ATL Zoning 2.0 Parking Zones

DRAFT - 12/4/24

Parking Zones

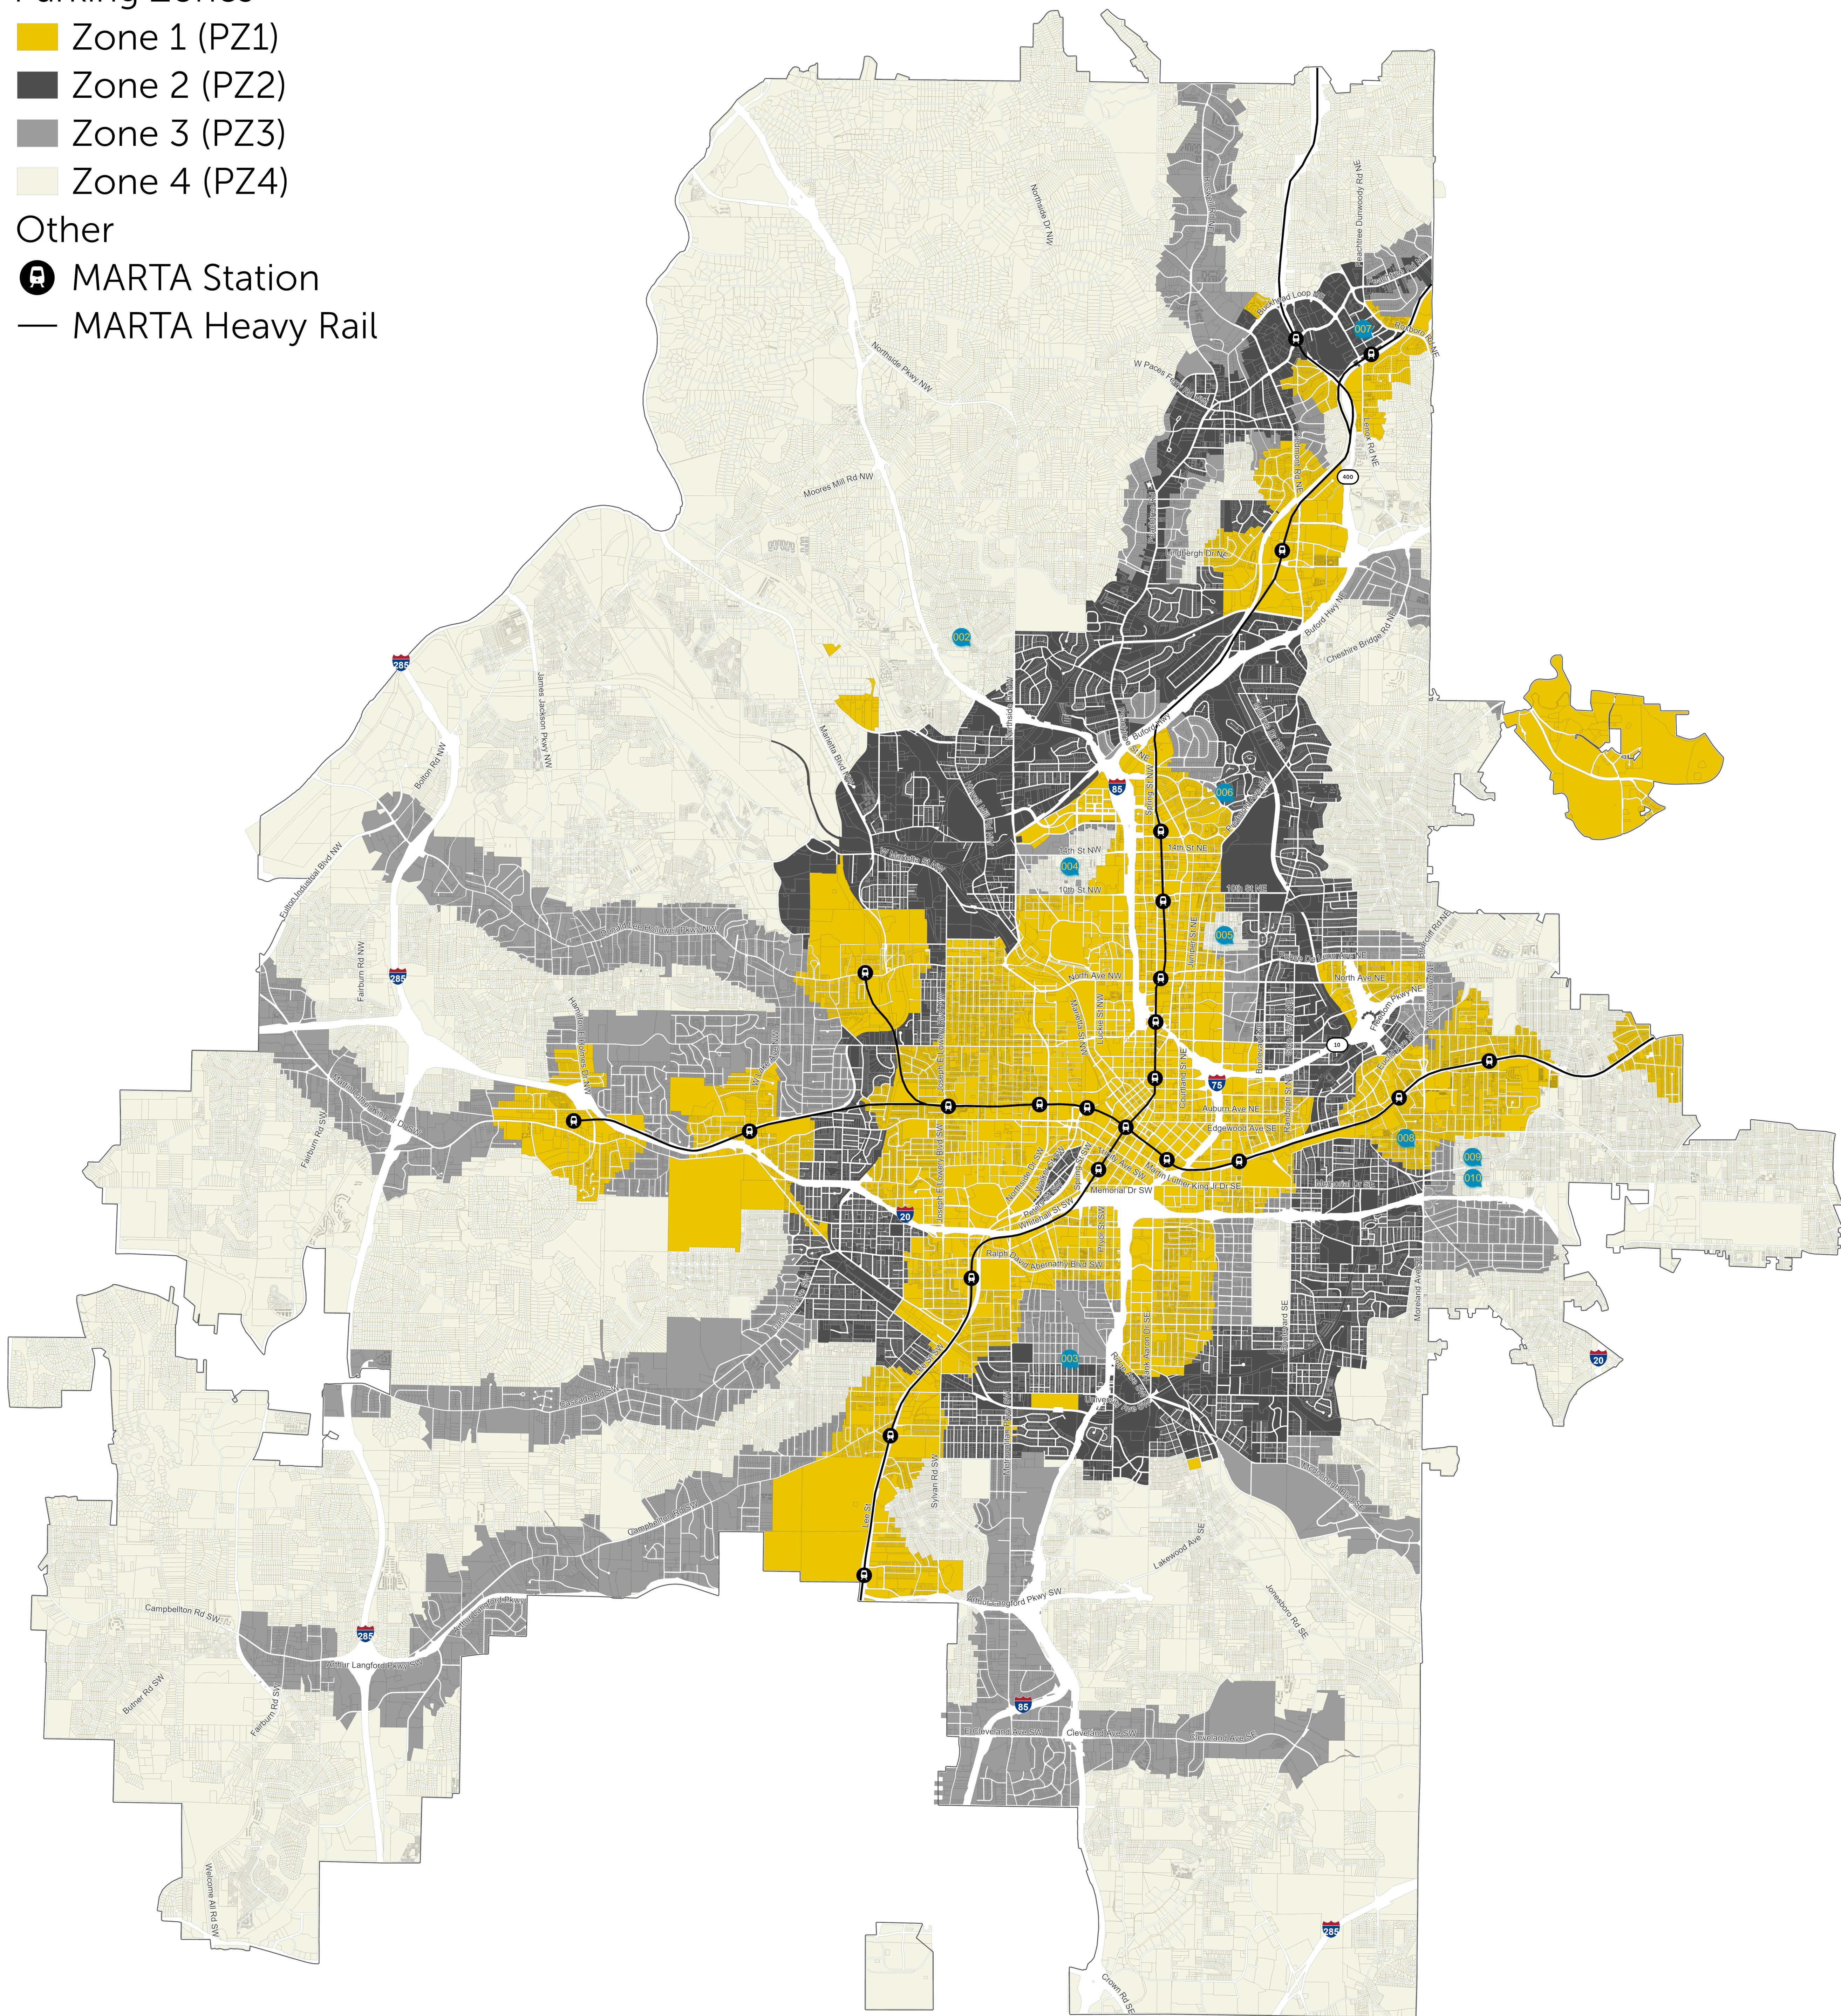
Parking zone locations seem to have no correlation to the Storefront Street Map. Is there a more granular way to determine parking requirements - based on adjacent street type, storefront requirements, etc? (This may already be provided elsewhere.)

Why does Atlanta need parking minimums anywhere? Austin, Minneapolis, Nashville, Raleigh, Richmond, San Jose, Seattle, and other cities have eliminated them citywide. This would go a long way towards decreasing reliance on cars and increasing space available for other means of transportation. It would also make housing cheaper.

This big block including pittsburgh and parts of Mechanicsville and Adair park should all be PZ2 if not PZ1. The section next to Pittsburgh yards being PZ4 is especially concerning. With the planned Metropolitan BRT line and the new focus on adding rail to the Southside Beltline, this area should be a focus for reducing vehicular travel, not increasing it.

This area, and almost everywhere else inside the Beltline, should be PZ2 at the minimum and preferably PZ1.

At a minimum this area of Midtown should be PZ3 at best it should be PZ1 with no minimums.

This is Midtown Atlanta and should encourage the best use of space with no parking minimums.

I thought 16-36.001 exempted R-4 zoned property from the Beltline Overlay parking regulations.

This is a dense mixed-use area with easy transit access. It should be PZ1.

Due to contemporary pushes towards densification, Wylie street and others have practically turned into a one way impassible street with all the beltline expansion and parking. Will PZ1 fix this?

Regarding Whitefoord Ave SE, a major thoroughfare for our community, we need some maximums and something that controls which side of the street you can park on - El Tesoro and upcoming restaurants (which we love) have increased parked cars exponentially and will soon make our neighborhood impassible. Therefore, PZ4 is not a good idea for these streets where traffic must pass through.

As you approach the major intersection of Whitefoord and Memorial, traffic stacks up so heavily and streets become impassible at rush hours, largely due to no parking controls in place currently. PZ4 is not going to work here.

1. Areas with no or low existing parking requirement (yellow and dark gray);
2. Major corridors with existing/future frequent bus service (gray); and
3. Existing standard regulations (light tan).

They are intended to align with transit and trail access and the general walkability of the neighborhood -- not the specific use of the property.

Thank you for your comments. This map is guided by existing City policies and regulations. The citywide elimination of parking requirements (e.g., PZ1 everywhere) would need to be a policy decision initiated by elected officials.

Thank you for your comment. This PZ4 area in Home Park reflects the current Home Park Parking Overlay, which imposes parking requirements that overrule other standards.

This was clarified at the January 13th Module III Q&A session. Please see time marker 31:00 here: <https://www.youtube.com/live/xyoqwjjt4b0>

Thank you for your comment. There are already parking requirements in Buckhead Lenox that do require parking for certain alcohol-related uses. Those are reflected here. PZ1 and PZ2 are identical, except that PZ2 does require parking for certain alcohol-related uses.

Thank you for your suggestions. PZ1 reflects the current "high-capacity transit" parking standard within a 1/2 mile walk of the Inman Park-Reynoldstown MARTA station. Concerns about street parking and operations should be directed to ATLDOT.

Thank you for your feedback. Zoning does not control the parking of vehicles in the public right-of-way. All such concerns should be directed to the ATLDOT.

Thank you for your feedback. Do you mean PZ1?
